Eugene School District 4j

Adams Elementary School - Restroom Addition

C.I.P. No. 420.104.100

## **ADDENDUM #2:**

#### Model SS-3003

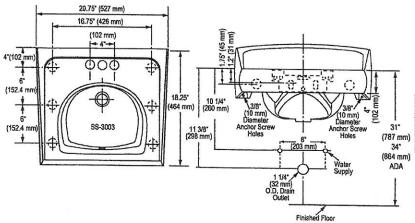
TO:	Rodd Hansen, Ar 1551 Oak Street, Eugene, Oregon	Suite A		DEADLINE	3:	November 4, 2014
PROJECT:	Adams Elementa Eugene School I	ıry School – R District 4J	estroom Additi	on		CIP # 420.104.100
ITEM:	99 49 00 ection No.	Page No.	2.1-A. Paragraph	Lav-	Wall H	ung
The Undersi	gned requests con	sideration of the	ne following su -3003	bstitution:		
/TV	<b>4</b> 0 0 00 00 00 000

See the attached substitution requests. All of the attachments have been approved and are
